RE: Refund, receipt # 58039, refunding \$506 for a perc test application at 12210 Hall Shop Road

RE: 12210 Hall Shop Road (Stull Property, Part 1), Percolation Certification Plan, comments

PERC CERTIFICATION PLAN STULL PROPERTY PART 1

TAX MAP #40 ZONED: RR-DEO PARCEL: 95
 3RD ELECTION DISTRICT HOWARD COUNTY, MARYLAND
 SCALE: 1" = 50' DATE: JANUARY 29, 2019

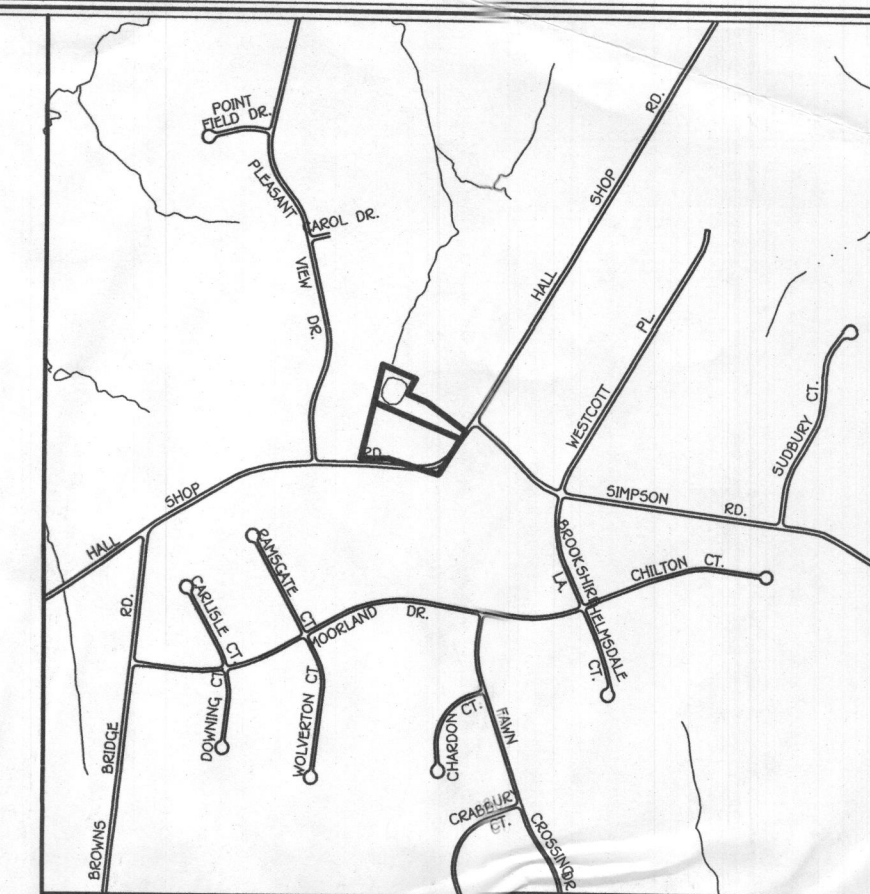
Edits are required in plan content, as described:

1. Include the property address as a subtitle for the plan.
2. In Replacement System design,
 - a. Delete the term "1st" in the title as there is only one replacement system,

- b. Use the design criteria issued on the spec sheet for the '2nd' Replacement, i.e.,
 - i. Effective Sidewall Begins at 4.0 feet, and
 - ii. Trench (Bottom) Depth is 5.5 feet.

3. Illustrate field-run 1-ft elevation contours in the sewage disposal area (SDA).
4. Edit General Note 7 as necessary.
5. The correct identifier for the perc test in the center of the SDA is '502'.

6. Attached is a graphic that is a markup on a photocopy of the Plan View.
 - a. Adjust the lower boundary of the SDA as indicated.
 - b. Adjust the upper boundary slightly, if needed.

- c. Consider the length and arrangement of the trenches sketched onto the markup. I placed the suggested locations for trenches working from the lower boundary toward the upper boundary.

7. In General Note 1, first sentence, delete the (19) words between PRIVATE SEWAGE AREA and AS REQUIRED. In essence, the first sentence begins by stating THIS AREA DESIGNATES A PRIVATE SEWAGE AREA AS REQUIRED BY THE MARYLAND....

8. In Notes 2, 4 and 9, replace the terms "EASEMENT" and "EASEMENTS", with the terms 'AREA' and 'AREAS', respectively.
9. Include the owner's name, the owner's address, and the owner's phone number on the plan.

10. Delete General Note 13.

11. Replace General Note 6 with this note:

12. Replace General Note 11 with this note:

13. Replace General Note 12 with this note:

THE WELL SHALL BE DRILLED PRIOR TO HEALTH DEPARTMENT APPROVAL OF THE BUILDING PERMIT FOR CONSTRUCTION OF A RESIDENCE ON THIS PARCEL. IT IS THE DEVELOPER'S RESPONSIBILITY TO SCHEDULE WELL DRILLING PRIOR TO SUBMITTING A BUILDING PERMIT PROPOSAL. IT SHALL NOT BE CONSIDERED 'GOVERNMENT DELAY' IF THE WELL-DRILLING HOLDS UP HEALTH DEPARTMENT APPROVAL OF THE BUILDING PERMIT APPLICATION.

THE SUBJECT PROPERTY HAS A LIMITATION OF THREE (3) BEDROOMS UNLESS AN EXHIBIT PRESENTED BY A CERTIFIED PROFESSIONAL DEMONSTRATES THAT THE SEWAGE DISPOSAL AREA WILL ACCOMMODATE THE WASTEWATER DISCHARGE FOR A RESIDENCE HAVING MORE THAN 3 BEDROOMS. A WAIVER TO THIS LIMITATION MAY BE AVAILABLE THROUGH THE BUREAU OF ENVIRONMENTAL HEALTH IF THE OWNER COMMITS TO INSTALLING AN APPROVED ADVANCED PRE-TREATMENT UNIT AS A COMPONENT OF THE SEPTIC SYSTEM.

AN INITIAL DRAINFIELD SYSTEM FOR A 4-BEDROOM RESIDENCE AND ONE REPLACEMENT DRAINFIELD SYSTEM FOR A 4-BEDROOM RESIDENCE WILL FIT WITHIN THE PROPOSED SEWAGE DISPOSAL AREA ON THIS PARCEL. THEREFORE, INSTALLATION OF AN ADVANCED PRE-TREATMENT UNIT IS REQUIRED TO QUALIFY FOR A WAIVER FROM THE REQUIREMENT THAT THE SEWAGE DISPOSAL AREA BE LARGE ENOUGH TO ACCOMMODATE AN INITIAL DRAINFIELD SYSTEM AND TWO REPLACEMENT DRAINFIELD SYSTEMS FOR THE RESIDENCE BEING PROPOSED. A SUPPLEMENTAL SITE PLAN WITH ALL OF THE NECESSARY DETAILS FOR INSTALLATION OF THE SEPTIC SYSTEM, INCLUDING THE ADVANCED PRE-TREATMENT UNIT, WILL BE REQUIRED PRIOR TO THE RELEASE OF THE BUILDING PERMIT.

PERC CERTIFICATION PLAN STULL PROPERTY PART 1

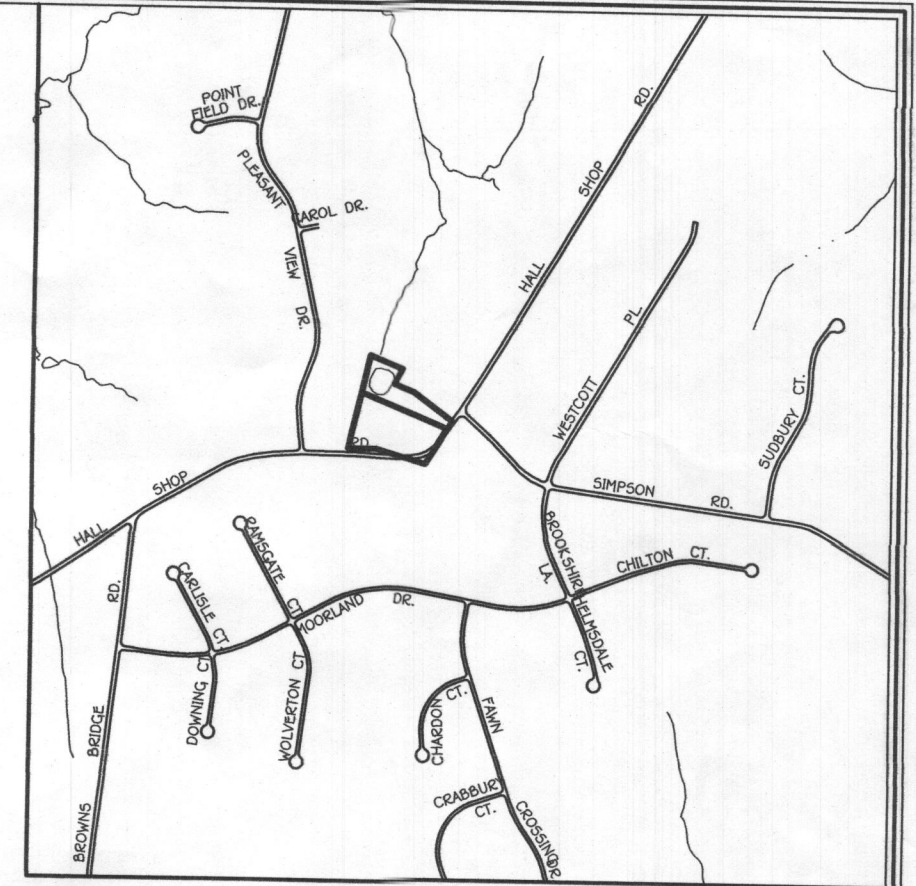
Hi Tony. Dana sent this PC up for signature and I have a comment for revision:

1. Note 1 is inaccurate for the project. The note should specify that it is showing area for an initial and one replacement system with pretreatment.
